Development Review Committee

STAFF REPORT

Re: AT&T Mobility Draper 845623-571785 – Permitted Use Permit Request

Application No.: USE-087-2022
Applicant: Kate Wythe of Crown Castle on behalf of AT&T Mobility
Project Location: Approximately 1661 E. 13200 South
Current Zoning: RA1 (Residential Agricultural, 40,000 square foot lot minimum)
Acreage: Approximately 5.25 acres (approximately 228,690 square feet)
Request: Request for approval of a Permitted Use Permit in the RA1 zone regarding approval to allow for an equipment upgrade on an existing AT&T wireless facility.

EQUIPMENT PLANS

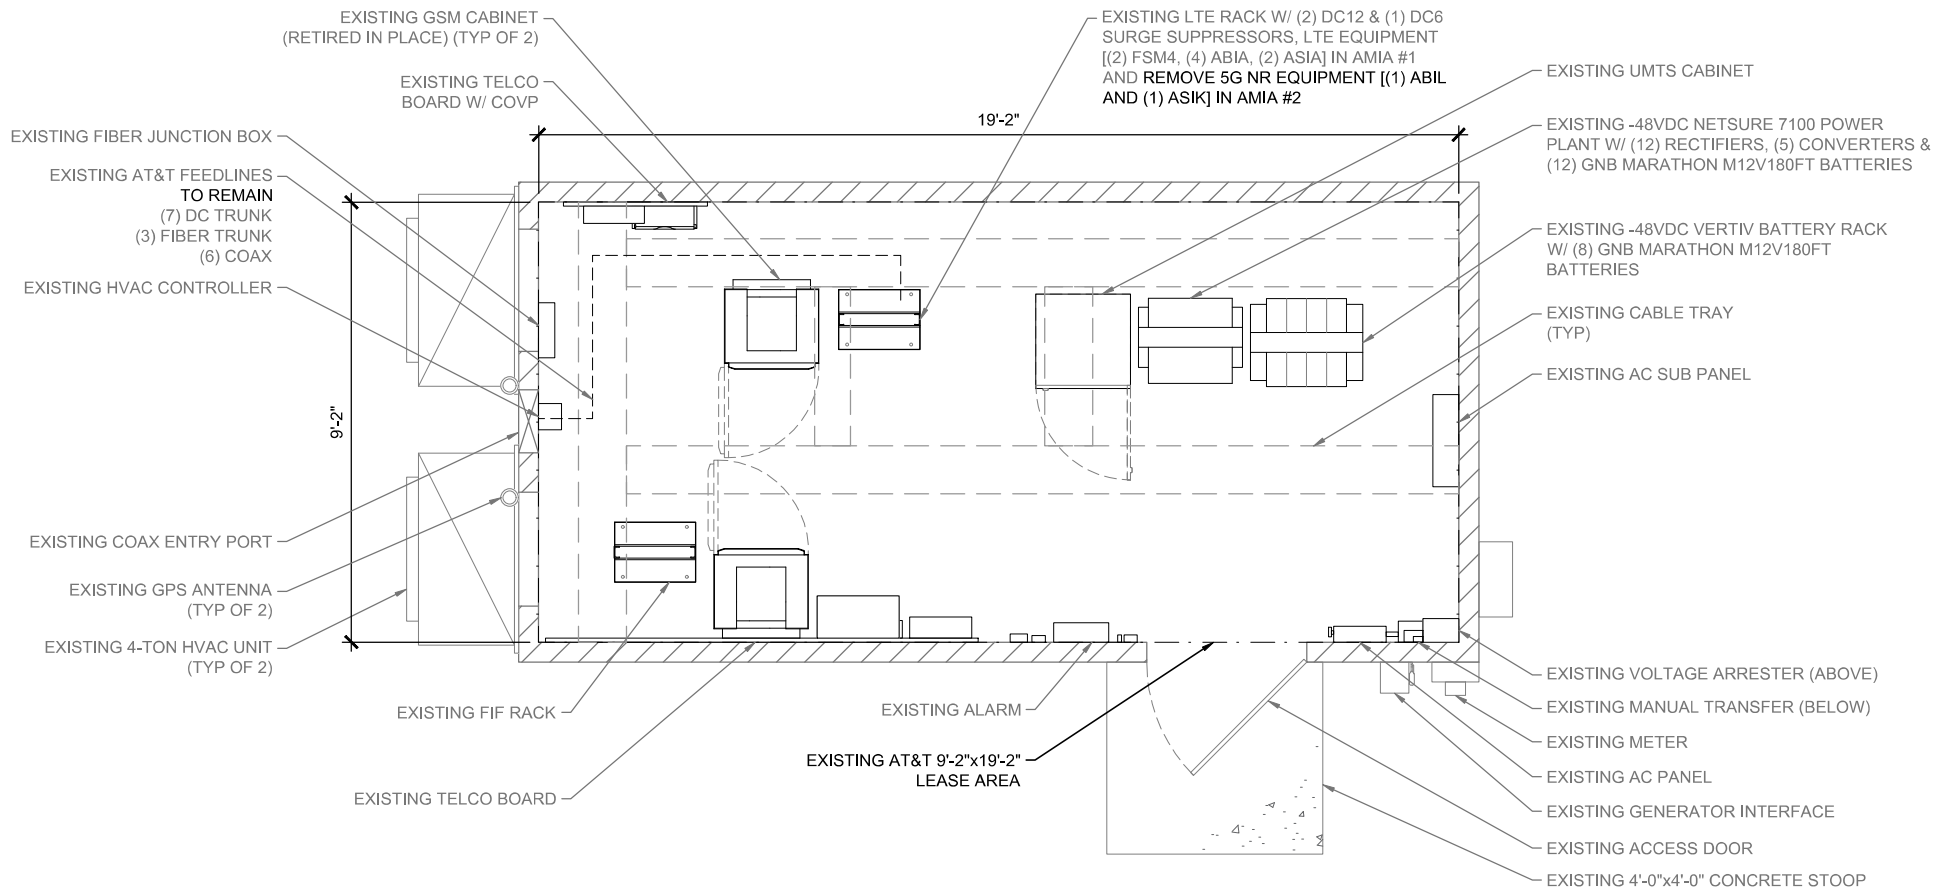
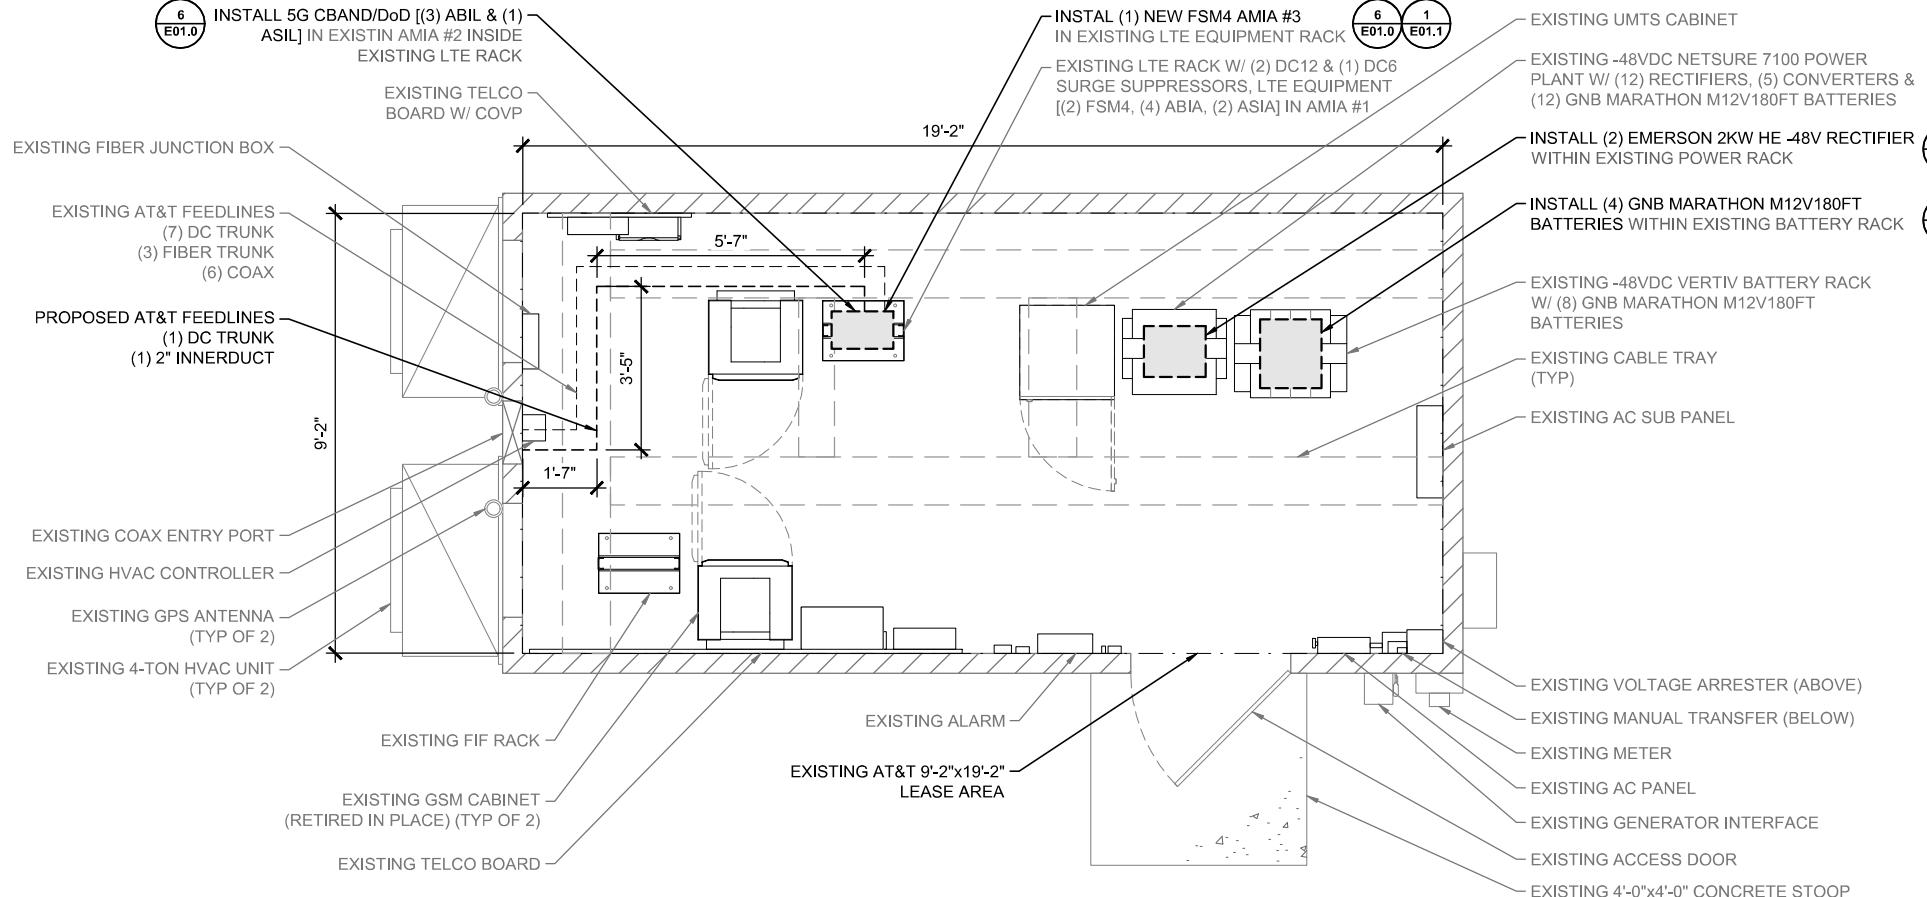
- REMOVE ONE ABIL AND ASIK FROM EXISTING FSM4 AMIA#2 IN EXISTING LTE RACK
- INSTALL 5G CBAND/DOD (THREE ABIO AND ONE ASIL) IN EXISTING AMIA #2 INSIDE EXISTING LTE RACK
- INSTALL ONE NEW AMIA #3 IN EXISTING LTE RACK
- INSTALL TWO EMERSON 3KW HE-48V RECTIFIER IN EXISTING DC POWER PLANT
- INSTALL FOUR GNB MARATHON M12V180FT BATTERIES INSIDE EXISTING BATTERY RACK
- INSTALL OR REUSE TWO 25A DC BREAKERS FOR THE NEW FSM4 (5G)
- INSTALL OR REUSE THREE 30A DC BREAKERS FOR THE NEW AHLBBA RRU'S
- INSTALL OR REUSE SIX 50A DC BREAKERS FOR THE NEW AEQK AND AEQU RRU'S

EAST ELEVATIONS

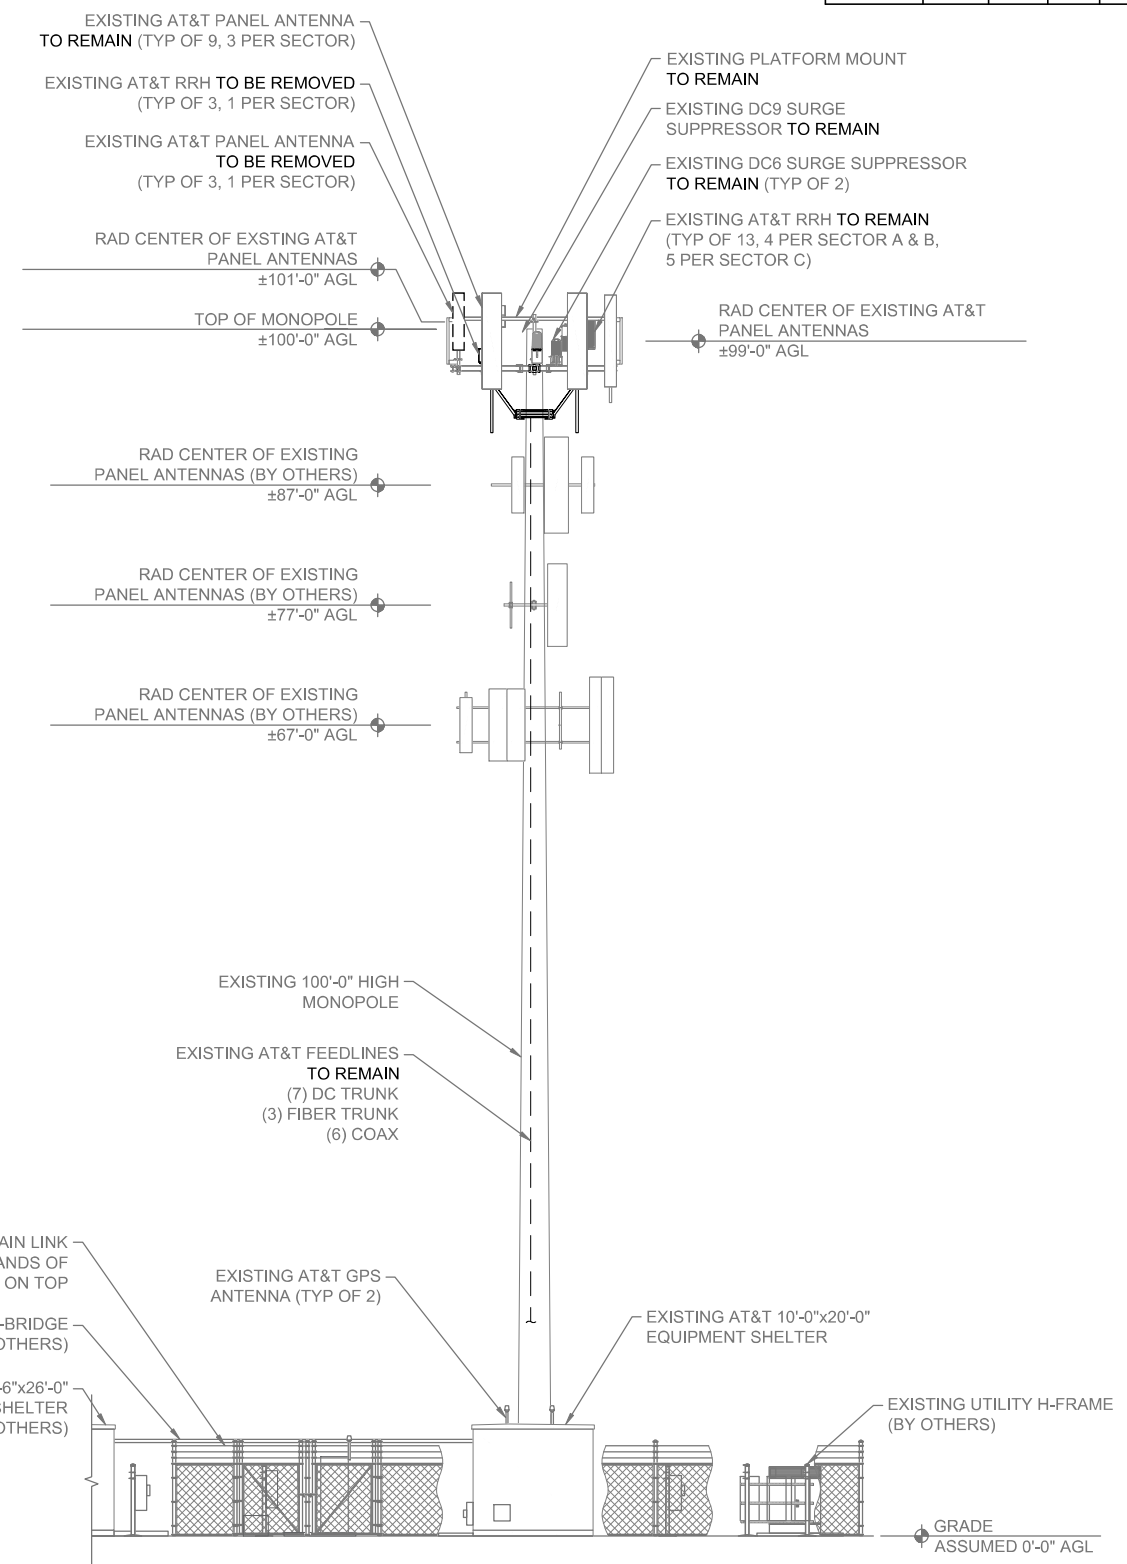
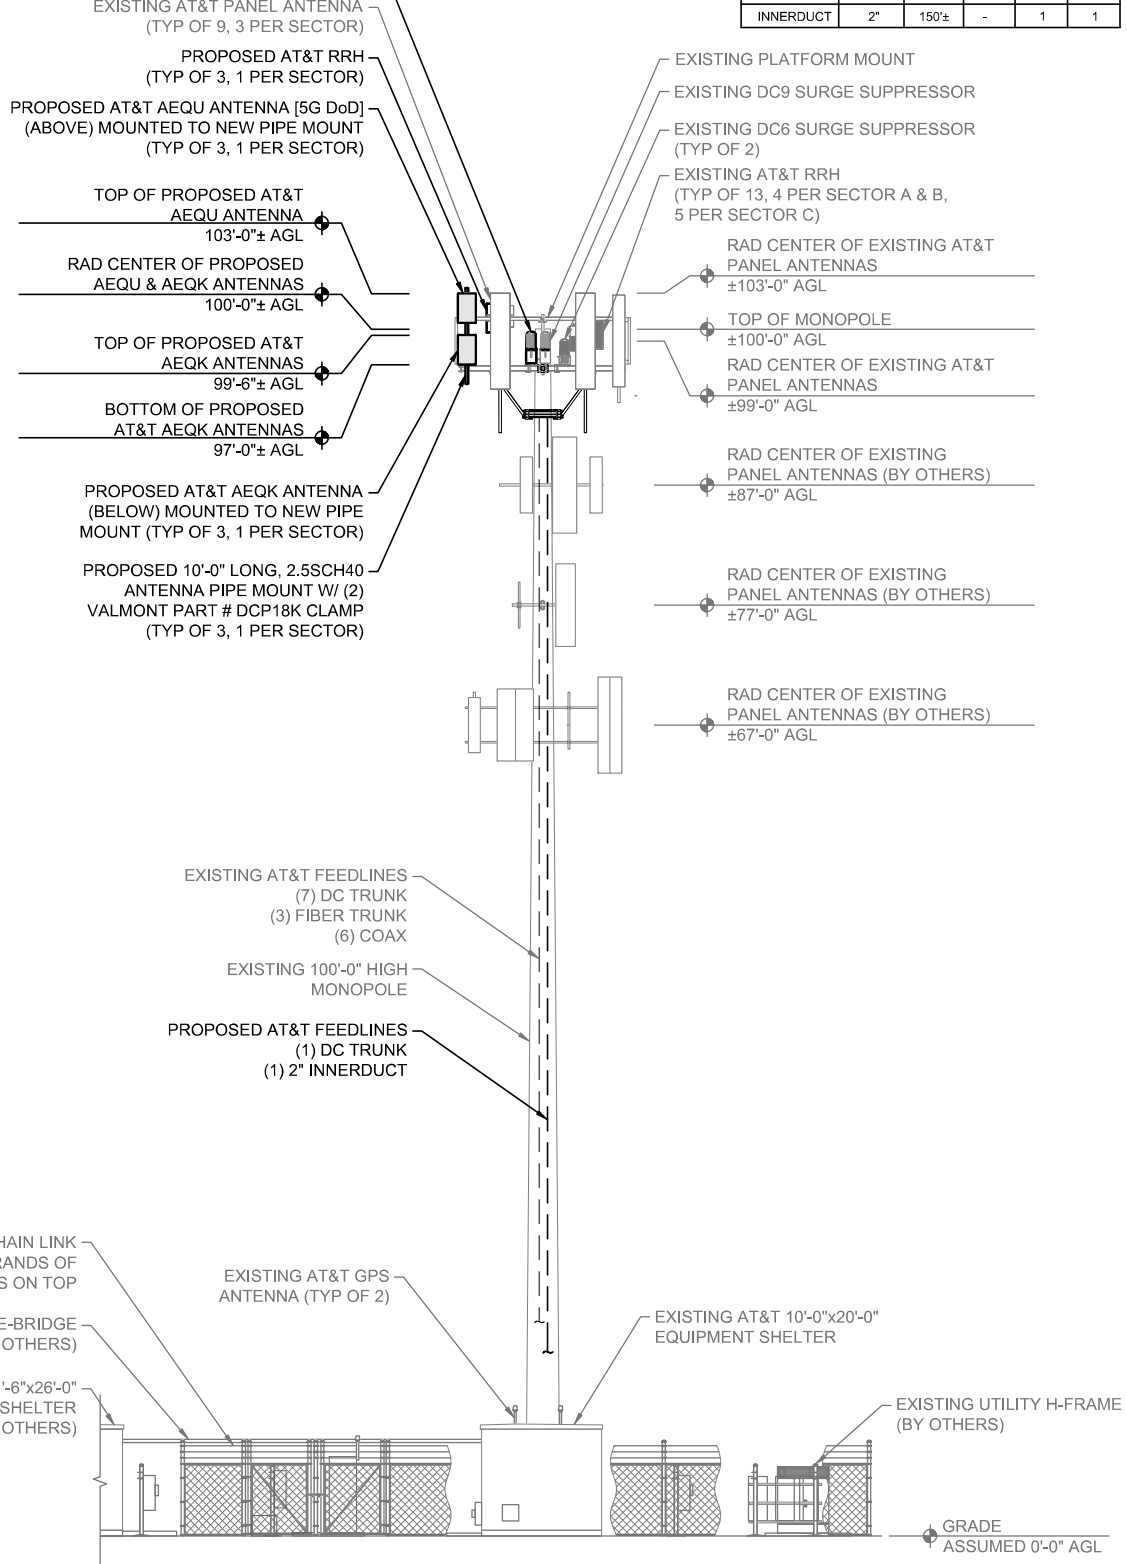
There will be no changes to the height of the structure or ground space. The proposed plan set is included at Exhibit E.

Drawing Title:
ANTENNA PLANS

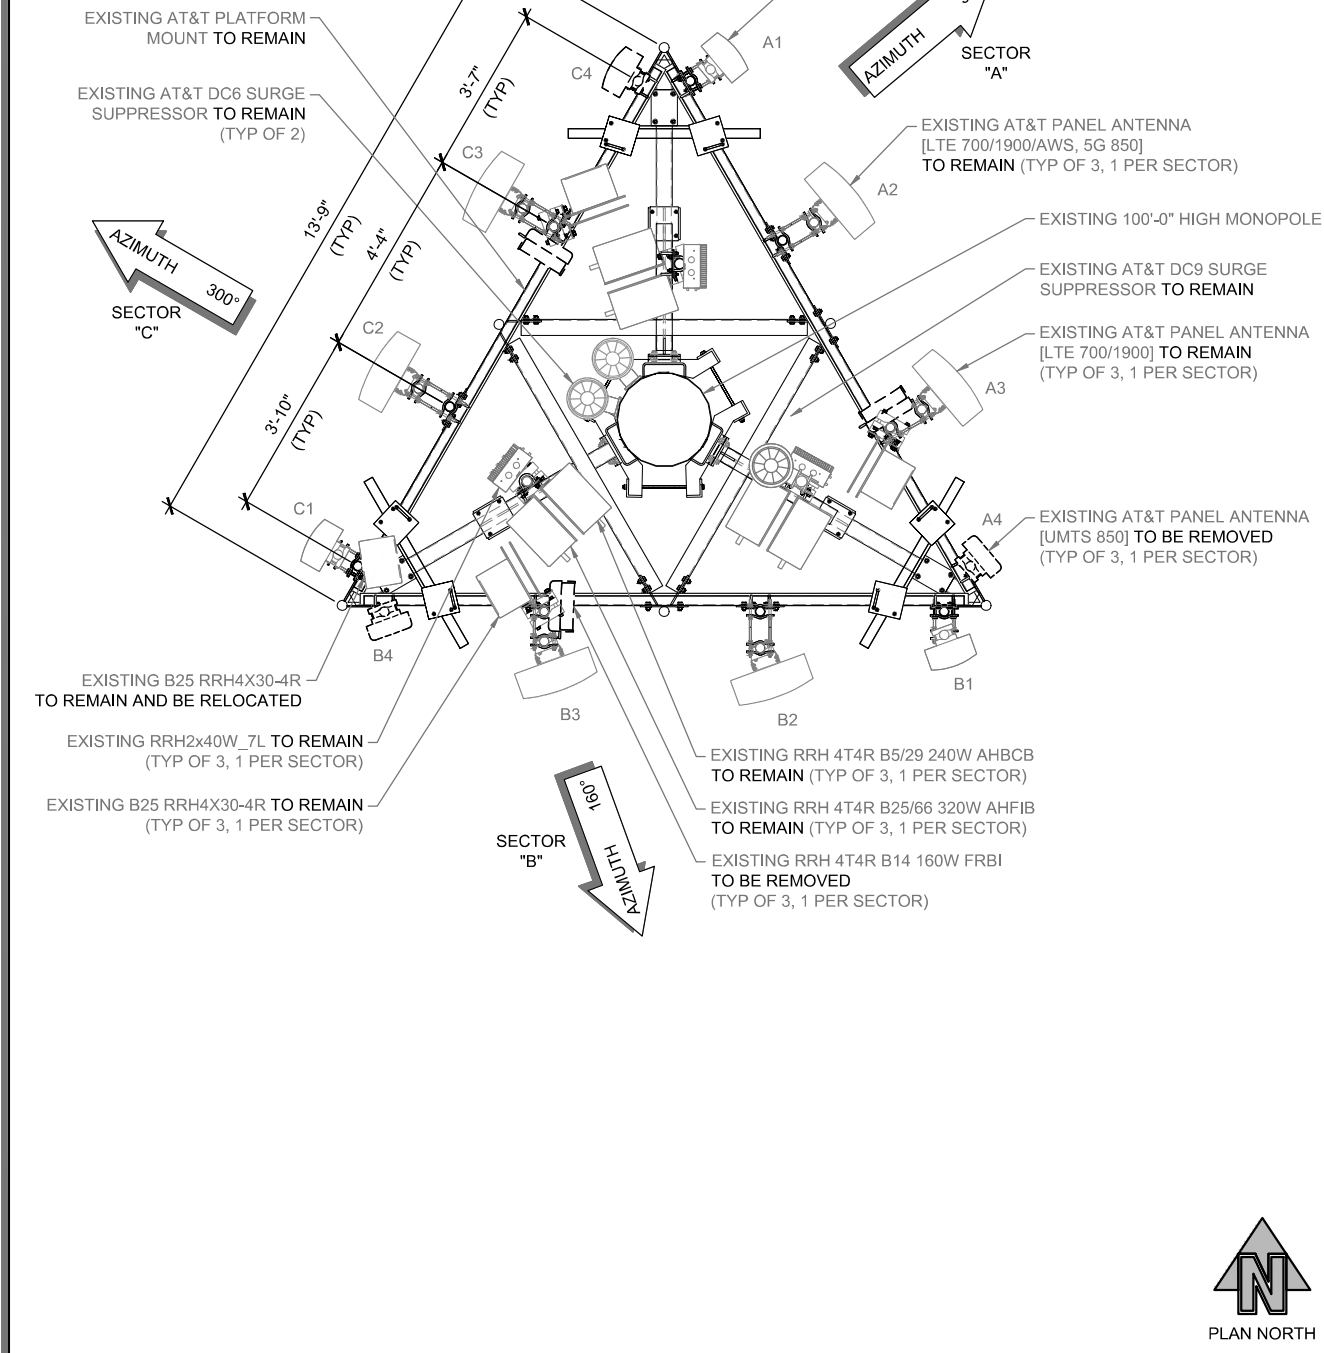
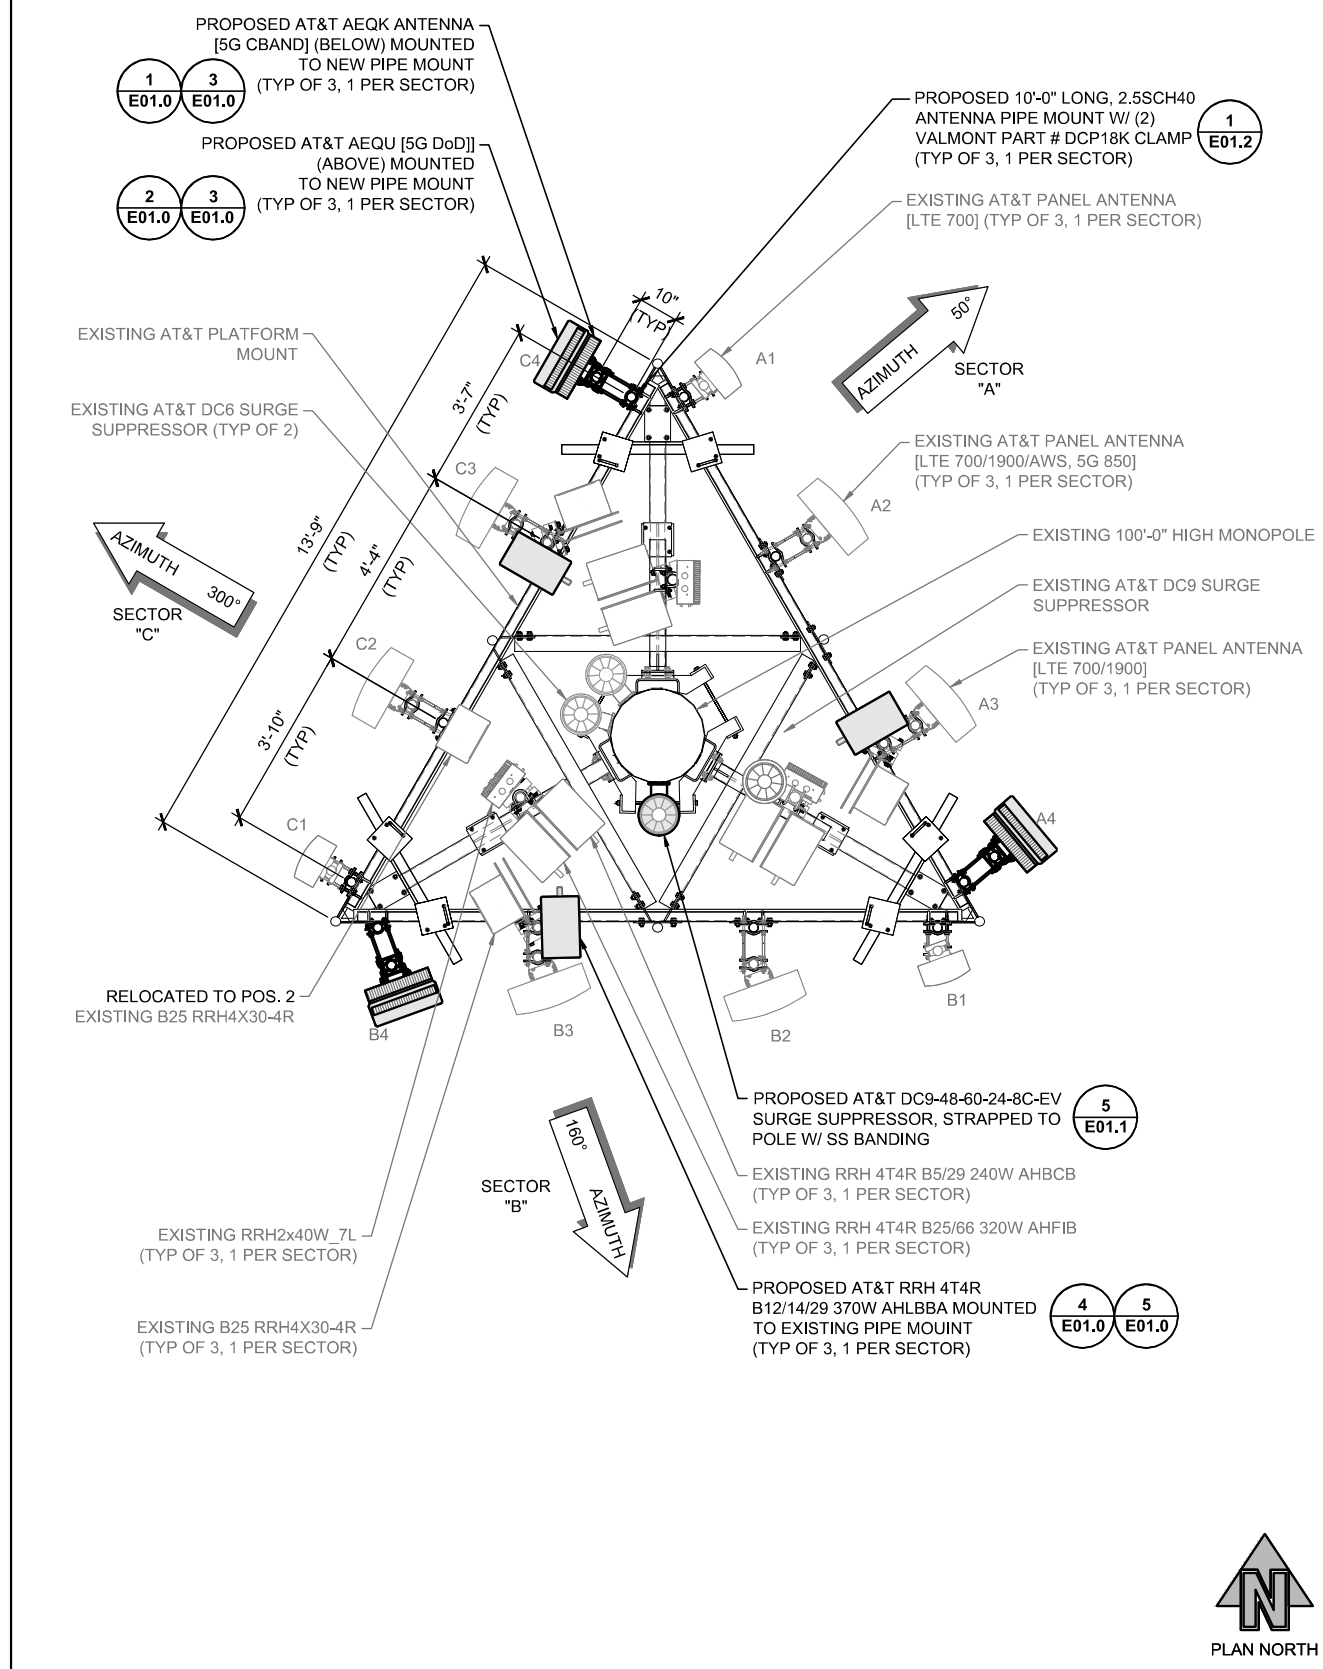
- REMOVE THREE PANEL ANTENNAS
- REMOVE THREE RRHS
- INSTALL THREE AEQK ANTENNAS
- INSTALL THREE AEQU ANTENNAS
- INSTALL THREE RRHS
- INSTALL THREE PIPE MOUNTS
- INSTALL ONE DC9 SURGE SUPPRESSOR
- INSTALL ONE 2-INCH INNERDUCT
- INSTALL ONE 6-#6 AWG DC TRUNK FROM EXISTING DC12 TO NEW DC9

- INSTALL ONE 2 #8AWG DC CABLE FROM DC9 TO NEW THREE AHLBBA, THREE AEQK AND THREE AEQU RRU'S
